Enclosure 1

PPL Response to SRBC Letter Dated January 19, 2011

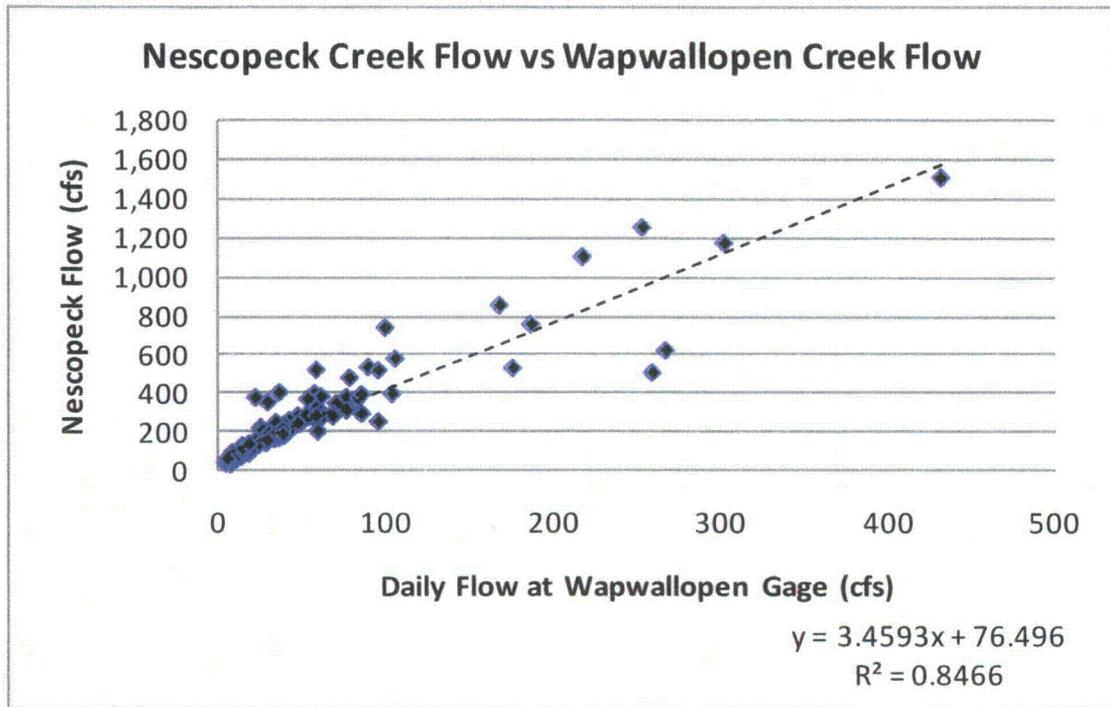
Comment 3

Section 3.1.1 states that, "Flow in the river between Nescopeck Creek and Fishing Creek will be assumed to be the sum of the Wilkes-Barre flow and the Nescopeck flow." The method to simulate flow needs to be further clarified. The stated method does not take into consideration: (1) the drainage in between the Wilkes-Barre gage and the Nescopeck Creek confluence with the Susquehanna River, which includes numerous tributaries to the Susquehanna River (including the U.S. Geological Survey [USGS]-gaged Wapwallopen Creek); (2) how flow will be simulated from a non-realtime Nescopeck Creek USGS gage; and (3) what flow will be simulated from the Nescopeck Creek USGS gage.

In Section 7 ("Water Quality Assessment of Nescopeck AMD Discharges"), we will document derivation of the proposed method for estimating the Nescopeck Creek flow for the days or time periods for which an estimated Nescopeck flow is necessary. This documentation will be presented in a separate subsection entitled "Estimating Nescopeck Creek Flows." The proposed method will be to correlate Nescopeck daily flow to daily flow gaged by USGS in the Wapwallopen Creek at Wapwallopen as follows:

$$\text{Nescopeck flow (cfs)} = [3.46 * \text{Wapwallopen flow (cfs)}] + 76.5 \text{ cfs}$$

Determination of the proposed correlation makes use of the approximately 140 Nescopeck Creek flows observed since 1949, as shown in the figure, below.
